**Re: Amendment #6 to the November 18, 2011 Application and Soil Management Plan
Northern Consolidation Area Design, April 2012
Birch Hills Golf Course
2250 East Birch Street, Brea, California**

Amendment #6 replaces Section 1.1, Element 2, Third Bullet at the top of Page 1-3, which was the original design for the northern consolidation area that will be used to consolidate PCB-impacted soil beneath the northern parking lot of the golf course. This letter provides an update to that original design based on discussions with EPA and OCHCA since the Soil Management Plan was submitted. Final dimensions will be adjusted in the field depending on the type of subsurface soil encountered and site utility locations. This letter is being submitted to EPA and OCHCA for design review and approval.

Figure: 3

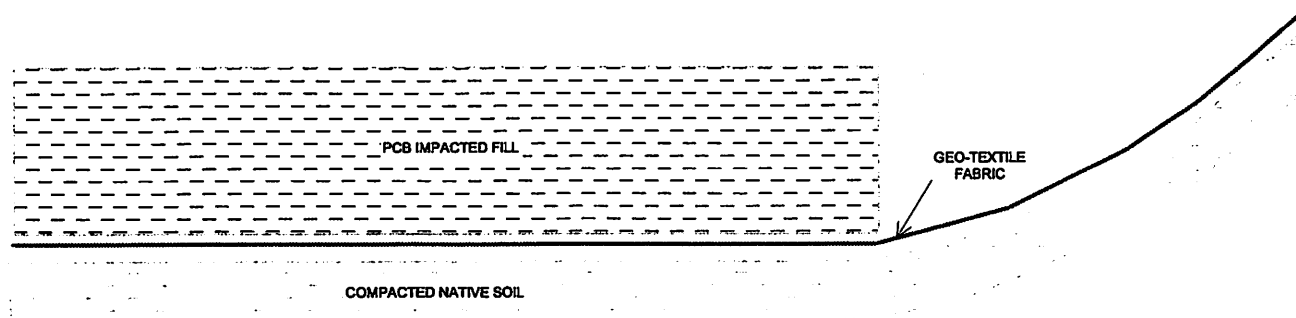
Impacted/Clean Soil Separation Liner – After the consolidated area excavation is complete, the base will be compacted to approximately 95 percent of optimum density, and then a liquid and gas permeable geo-textile material will be installed to provide a visual separation between the impacted material and clean soil (Figure 3). The same geo-textile material will be used on the sides of the consolidation area.

Cap and Surface Liner – The basic cap design will follow the requirements presented in the Code of Federal Regulation 761.61(a)(7), as summarized below (Figure 3):

- After the impacted soil was been consolidated and compacted to 90% optimum density, six-inches of sand will be placed as a base, then a 36-mil polypropylene liner meeting the requirements for low permeability noted in 761.75(b)(1) and minimum thickness noted in 761.75(b)(2) will be installed as the most cost-effective consolidation area cap. The cap surface will have a 2 percent slope to drain any infiltrating water away from the cap;

- 6-inches of sand will be installed as a water drainage system on top of the liner. Perforated pipe will be placed along the downslope cap edge to drain the water into the golf course stormwater drains and/or the driving range (overflow stormwater basin for the project);

- A filter fabric will be placed on top of the sand layer to minimize infiltration of fines;
- 5-feet of clean fill will be installed to provide space for utility installation such as an electrical lines to the parking lot lights or feeder lines to the parking lot fire hydrants as required by the City of Brea Fire Department. The top of these utilities is required by the City of Brea to be at least 42-inches below ground surface;

- The final surface will be covered by 4-inches of asphalt and 8-inches of crushed aggregate for portions under the parking lot or 12-inches of compacted site soil for portions under the adjacent landscape. A storm drain system will be installed as part of the parking lot construction to channel stormwater away from the consolidation area as an additional water infiltration control. Landscape covering the portions of the consolidation area outside the parking lot will be limited to golf course grasses and shallow rooted trees/brush and the surface will also be sloped to channel stormwater away from the consolidation area; and

FIGURE 2-CONSOLIDATION AREA WITH CROSS-SECTIONS 4-21-12

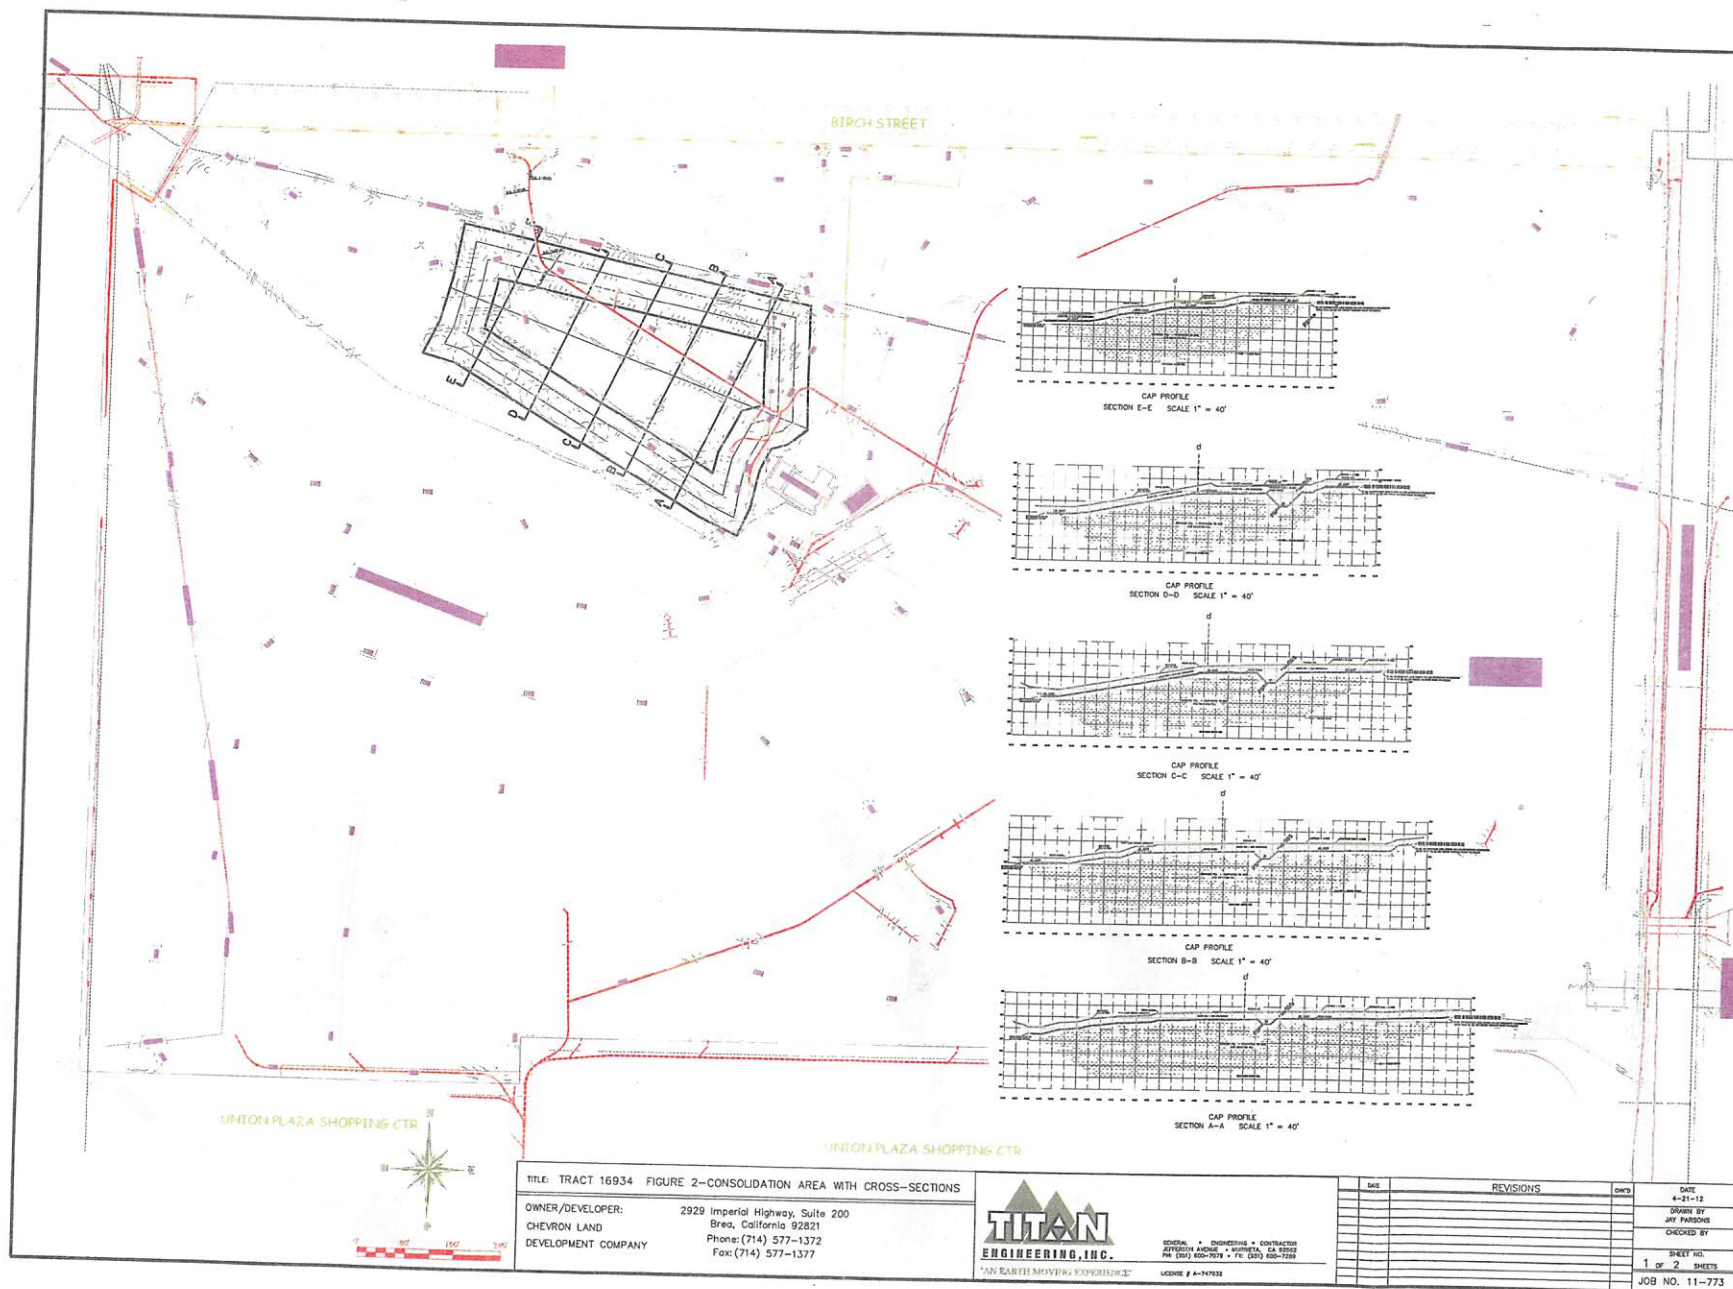
Location and Size – The consolidation area location is shown on Figure 2. The general trapezoidal shape has the following approximate dimensions – north (590 feet), east (400 feet), south (600 feet), and west (220 feet). Surface acreage is approximately 4.1 acres and total volume available for impacted soil consolidation is approximately 196,000 cubic yards. The northern and eastern boundaries will be constrained by the presence of a high pressure natural gas pipeline and a potable water pipeline to the north, and a high pressure gas line and an electrical line leading to the clubhouse to the east (Figure 2).

Depth – The consolidation area surface elevation will range from approximately 412 feet mean sea level (ft msl) in the north to 380 ft msl in the south as shown in the cross-sections on Figure 2. The consolidation area base will range from approximately 355 ft msl in the north to 338 ft msl in the south for an approximate total depth of 50 feet below ground surface (ft bgs). The side slope will be approximately 1.5:1 depending on subsurface soil type and conditions, as well as maximum slopes suitable for vehicle entry and exit from the consolidation excavation. The deepest portion of the base will be approximately 19 feet above highest known groundwater based on data from monitoring well MW-4A, which was installed on the southwest corner of the driving range and had water elevations ranging from
